UNITED STATES
NUCLEAR REGULATORY COMMISSION
WASHINGTON, D. C. 20555

March 28, 1980

Docket No. 50-245

RE: ENVIRONMENTAL QUALIFICATION OF ELECTRICAL EQUIPMENT

FIGURE 1

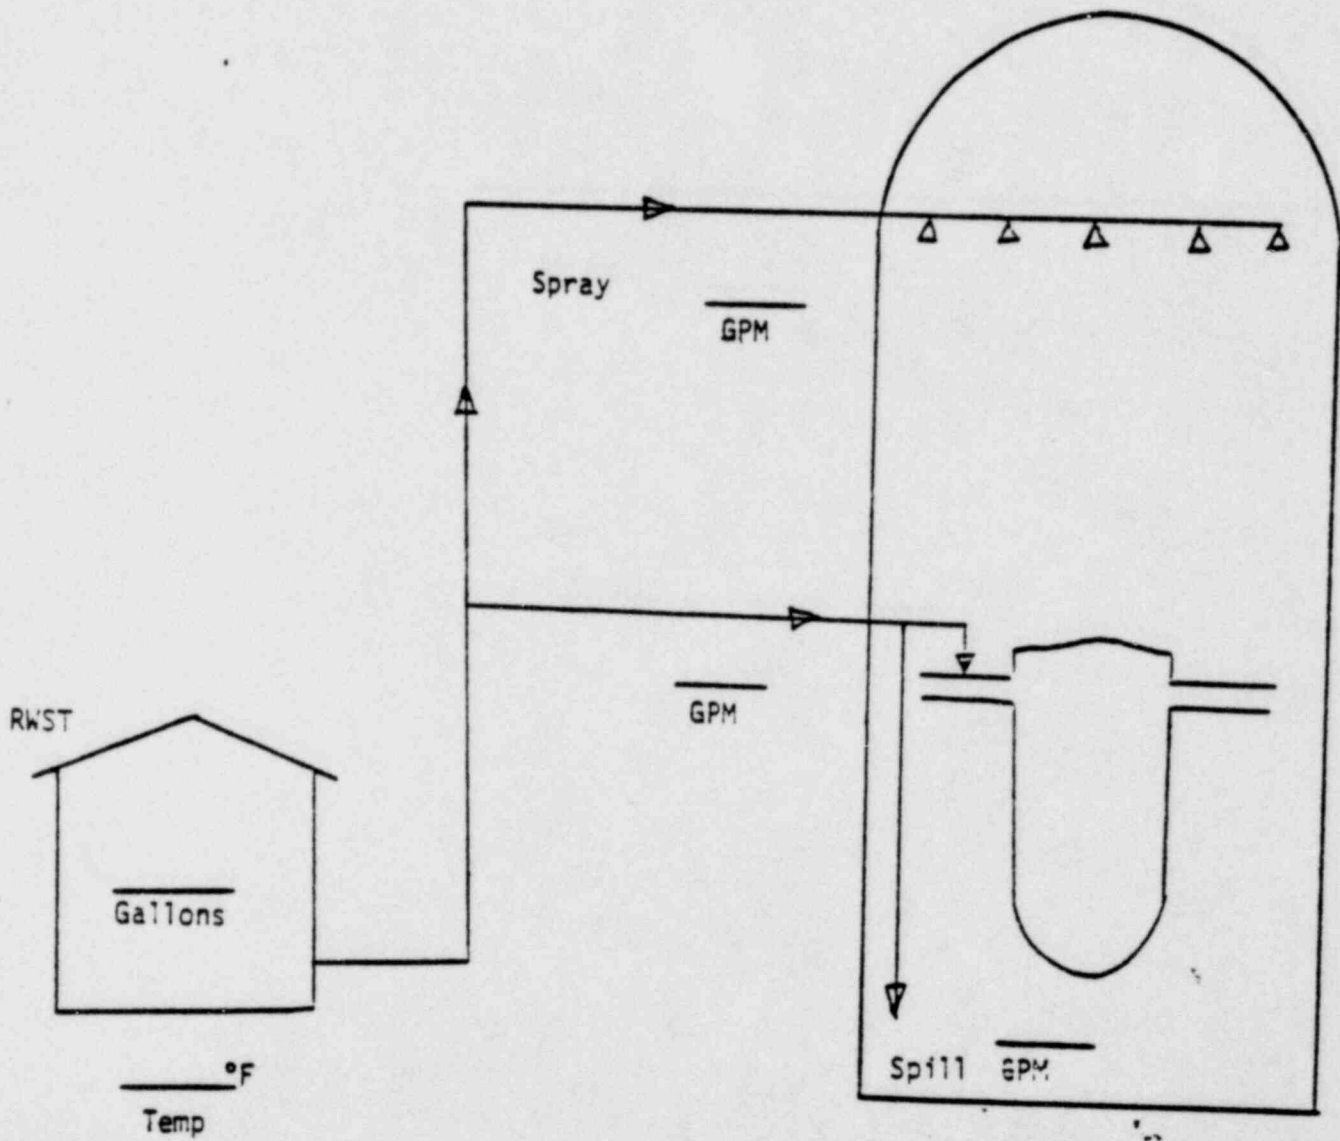
II. Figure 1 and 2 represent typical ECCS and spray systems relied on to mitigate the consequences of a pipe break. Provide the information indicated in the figures; if the plant specific systems differ from the attached figures, revise the drawings to represent your facility and provide the appropriate information.

When providing system parameters, indicate whether the values given assume a single failure and specify the single failure assumption.

FIGURE 1 - INJECTION PHASE

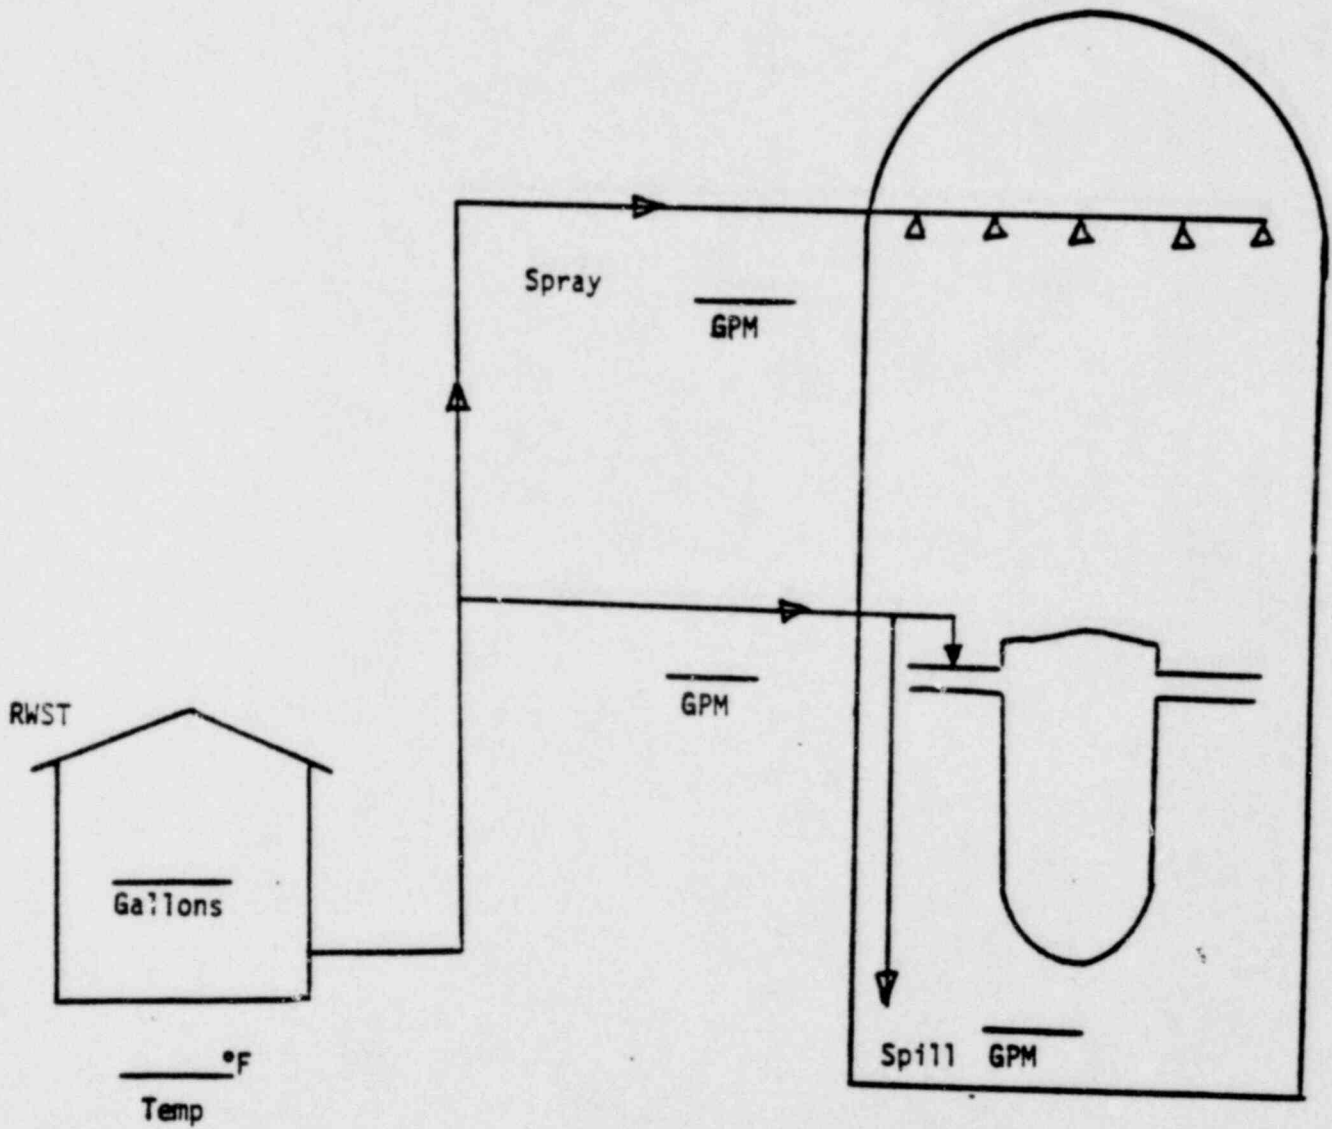
When providing system parameters, indicate whether the values given assume a single failure and specify the single failure assumption.

Figures 1 and 2 represent typical ECCS and spray systems relied on to mitigate the consequences of a pipe break. Provide the information indicated in the figures, if the plant specific systems differ from the attached figures, revise the drawings to represent your facility and provide the appropriate information.
